Re: FortisBC Inc. (FBC)

**Application for a Certificate of Public Convenience and Necessity for Approval
of the Fruitvale Substation Project (Application)**

**Response to the Industrial Customers Group (ICG) Information Request (IR) No.
1**

22 **Table 1: FRU Summer and Winter Peak Loads 2014-2023**

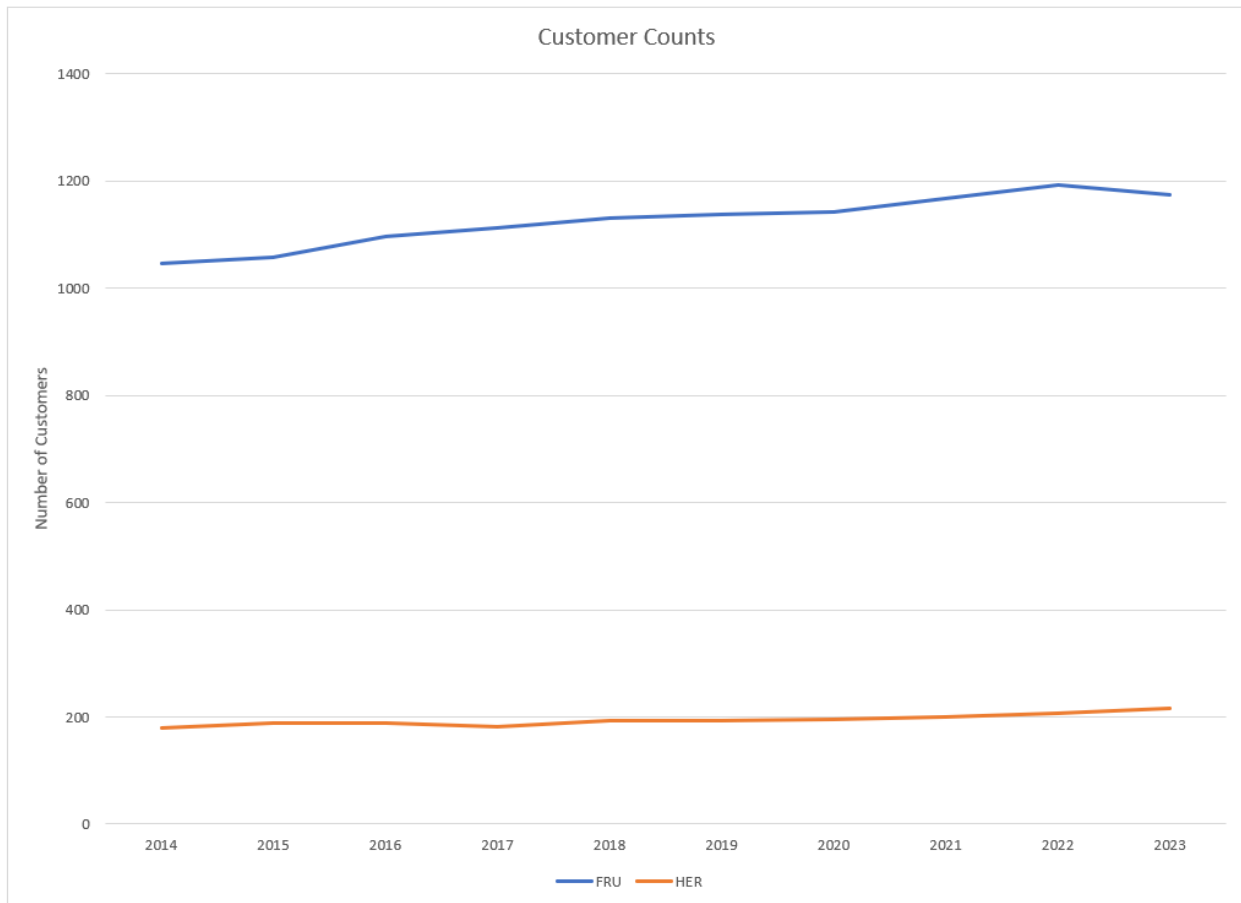
4 1.1 Further to BCUC IR 3.1, please provide a graph and table of the annual peak winter
5 and summer loads served by each of the FRU and HER substations over the last
6 10 years, and specify if any peaks at one station include loads transferred from the
7 other station.

10 FBC provides the requested information in the table below and in Attachment 1.1. FBC notes the
11 following with respect to the information provided:

- 12 • The “FRU T1 Winter Peak (MW)” considers the winter season spanning from November
13 to February. Therefore, the peak values provided in the table could have occurred at any
14 time from November of the listed year to February of the following year. For example, the
15 2014 peak load data below considers the range November 2014 to February 2015.
- 16 • Load data is not available for HER as there is no metering at the HER substation. Metering
17 has not been installed at HER as the substation was planned to be decommissioned, and
18 the maximum capacity of the substation is only 1.875 MVA.
- 19 • Temporary load transfers due to planned outage work are not considered when
20 determining peak load. The table below does not consider load transfers to FRU T1 when
21 determining the summer and winter peak load values.
